**ELECTRONIC AGENDA PACKET FOR
THE PUBLIC HEARING OF
MONDAY, APRIL 11, 2022
7:00 P.M.***

PUBLIC HEARING AGENDA OF THE LIVONIA CITY COUNCIL
Monday, April 11, 2022
7:00 P.M.
Livonia City Hall Auditorium
33000 Civic Center Drive, Livonia, Michigan

Petition 2003-08-SN-08 submitted by Aver Sign Company requesting to amend Council Resolution #549-03, adopted by the Livonia City Council on October 22, 2003, to allow the illumination of tubing around the pump island canopy of the BP gas station at 27428 Schoolcraft Road, located on the northwest corner of Schoolcraft and Inkster Roads in the southeast ¼ of Section 24.

Petition 2021-11-08-06 submitted by Jeffery Scott Architects requesting approval of all plans required by Section 13.13 of the Livonia Vision 21 Zoning Ordinance, in connection with a proposal to remodel the exterior facade and modify the approved landscape plan of the commercial strip center at 16112 thru 16184 Middlebelt Road, located on the east side of Middlebelt Road between Five Mile Road and Terrence Avenue in the Northwest ¼ of Section 13.

SHEET TITLE:
GAS STATION
CANOPY

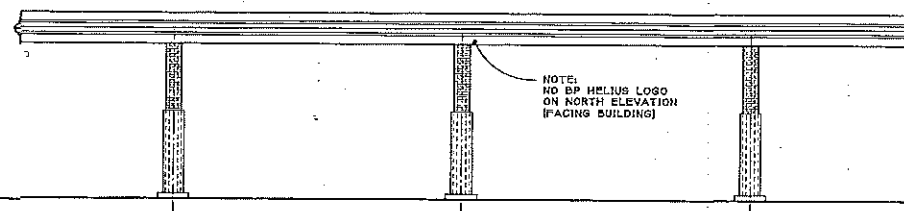
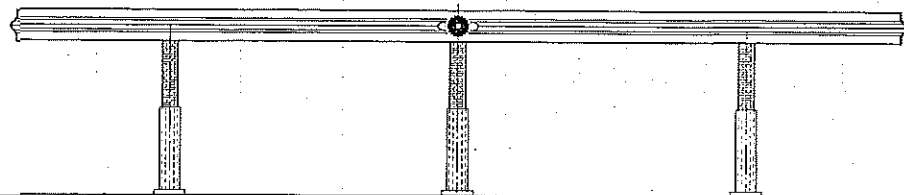
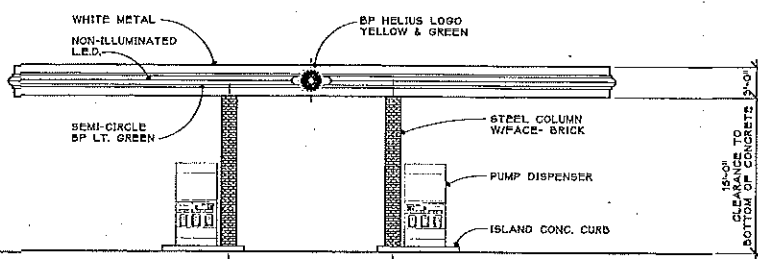
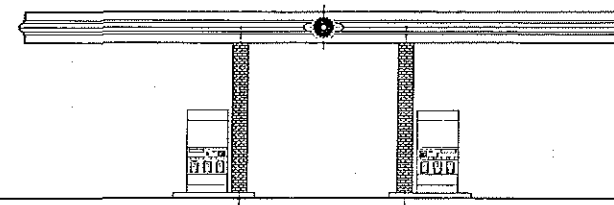
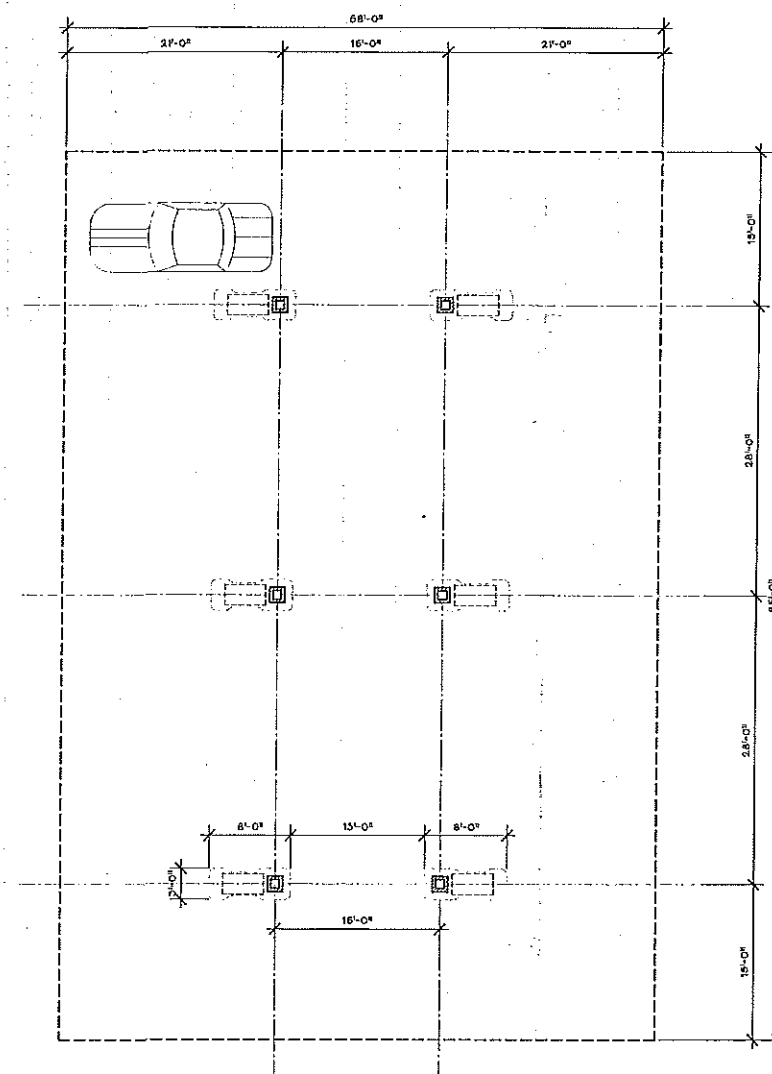
The petitioner is requesting to amend this condition to allow LED tube lighting around the perimeter of the pump island canopy fascia. The tubing was shown on the original plans with a note that it would not be illuminated. The Petitioner notes that there are other gas stations located around the city with various forms of canopy fascia illumination. While this is true, the restriction imposed on this project is consistent with the action taken on most commercial developments, including gas stations, and is supported by the following prohibition as set forth in Section 11.05(7) of the Livonia Vision 21 Zoning Ordinance, which provides:

The area of the tubing around the pump island canopy is measured according to its width times its entire length. The tubing is one inch (1") in width and the total length of the three sides of the canopy measures 221 feet (68' + 68' + 85'). The area of the tubing, not including the BP logo signs, measures approximately eighteen (18) square feet. The three (3) circular BP logo signs on the canopy each measure eleven (11) square feet. Added together, the signage on the building (30 sq.ft.) plus the canopy (51 sq.ft.), totals 81 square feet, which is nineteen (19) square feet less than the 100 square feet allowed under the zoning ordinance.

1. That the proposed modification is not supported by the Livonia Vision 21 Zoning Ordinance which prohibits outline tubing signs.
2. That it has been a long-standing policy by the City not to allow this type of illumination around pump island canopies.
3. That the applicant has not justified the need to illuminate the pump island canopy at this location.
4. That the petitioner has failed to affirmatively show that the proposed modification would be aesthetically in the City's best interest.
5. That approving this type of illumination would set an undesirable precedent for businesses of this type.

LP - 1: LANDSCAPE PLANTING PLAN

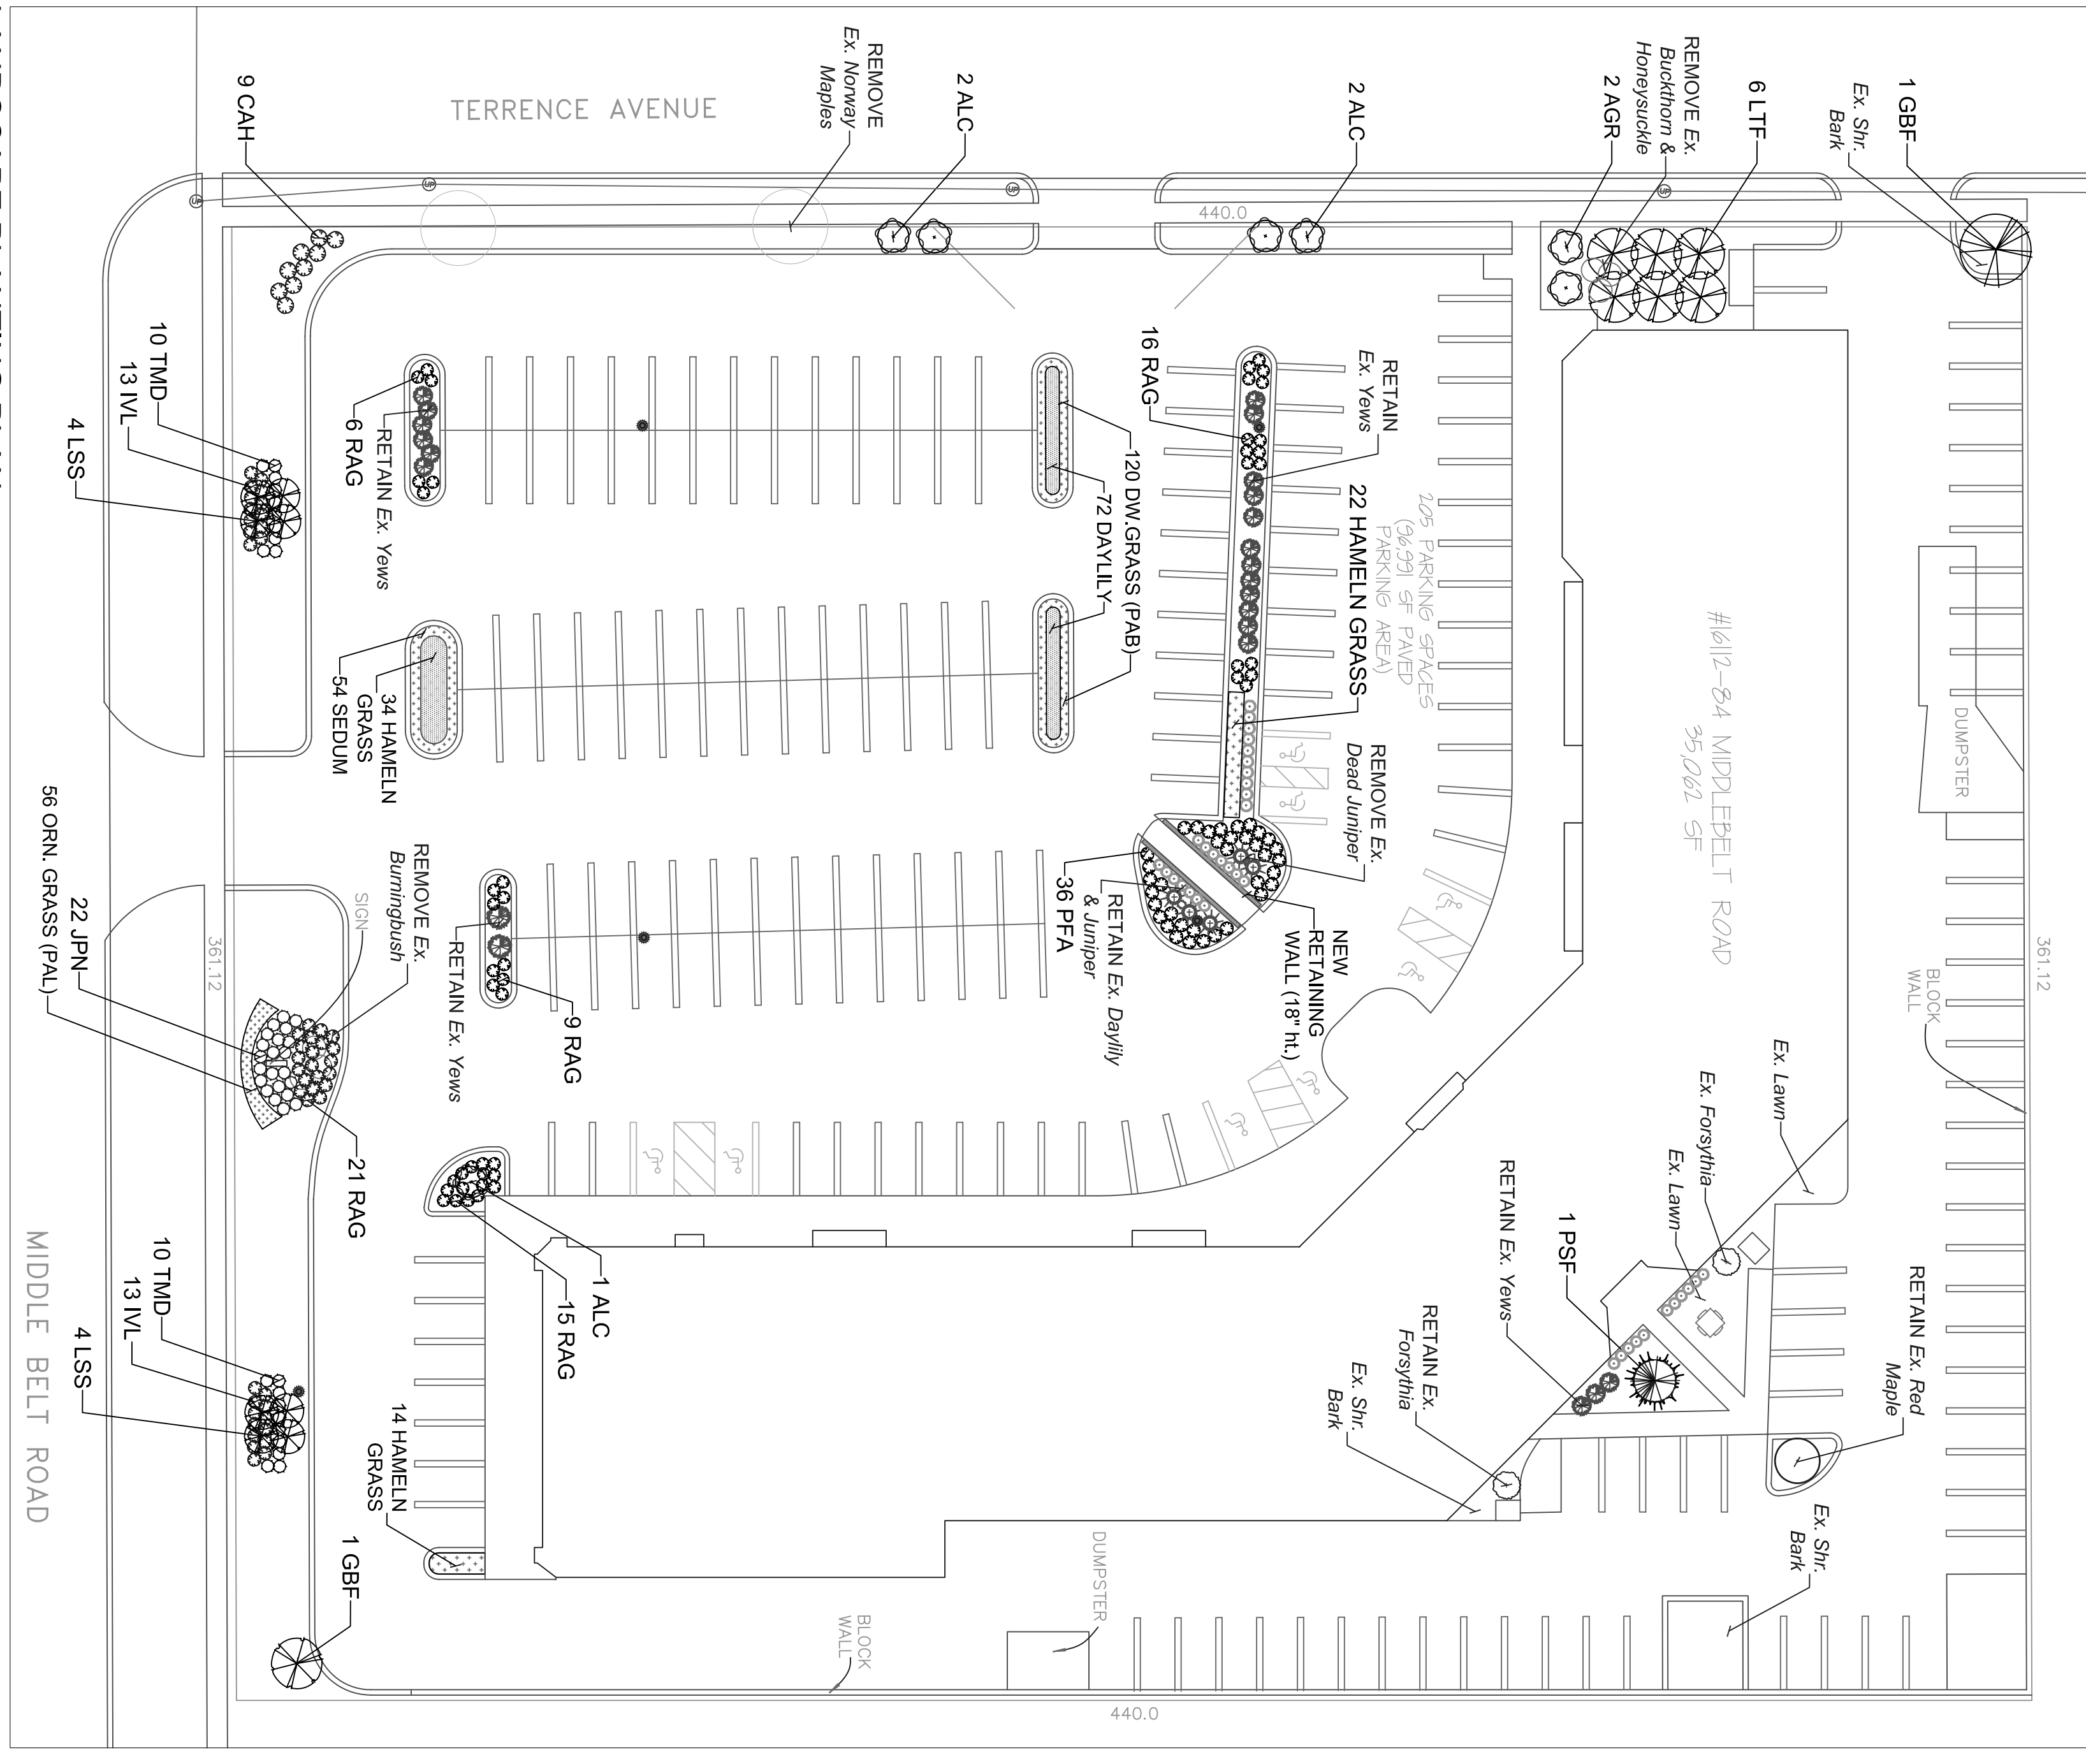
The Department further noted that the Petitioner's application for the revised landscaping and remodel of the exterior of the shopping center did not show any additional trees but proposed mostly shrubs and other ground cover, ornamental grasses and spreading junipers, grouped, and installed along the street frontage of Middlebelt Road and within the center's parking lot islands. No new plant materials were planned for Terrance Avenue.

1. That the petitioner has failed to comply with all general standards and requirements as set forth in Sections 1.02, 10.03 and 13.13 of the Livonia Vision 21 Zoning Ordinance.
2. That the lack of trees shown on the proposed landscape plan would have a negative effect upon the neighboring properties, as well as the City as a whole.
3. Allowing this would be detrimental to the aesthetic quality and appeal of the overall site, and negatively alter the character of the property.

First, the City Council should recognize that the Planning Department provided an erroneous analysis of the plantings required for the site under the new zoning ordinance standards. The Department wrongly estimated that “the frontage along Middlebelt Road requires no fewer than nine (9) full size trees, four (4) ornamental trees and seventy-two (72) shrubs, and the frontage along Terrance (sic) requires eleven (11) full size trees, five (5) ornamental trees and eight-eight (88) shrubs.” The Department erred by failing to adjust for the driveway openings and thus overestimated the number of required trees and shrubs. (See Section 10.03 (1)).

Second, following the February 1, 2022, study session, and despite the Petitioner’s strong belief that its originally submitted landscape design would be very aesthetically pleasing, it prepared a revised landscaping plan which it presented at the February 8, 2022, public hearing, and meeting to address the Planning Commission’s and Department’s concerns. The revised plan followed the Article 10, Section 10.03 requirements as faithfully as possible and proposed a total of 16 deciduous or evergreen frontage trees and 6 ornamental trees for the frontages along Middlebelt and Terrance. The plan contained 98 shrubs for the road frontage. It also however proposed 2 trees for the parking lot (one tree exists) and 86 more shrubs in the parking lot, which included 20 existing shrubs. The proposed deciduous and ornamental trees meet the minimum caliper requirements as provided in the zoning ordinance.

The revised landscaping plan therefore only requires a modification to eliminate two required deciduous or evergreen tree, one ornamental tree and 43 shrubs for the frontage. There was no comment on the parking lot landscaping.
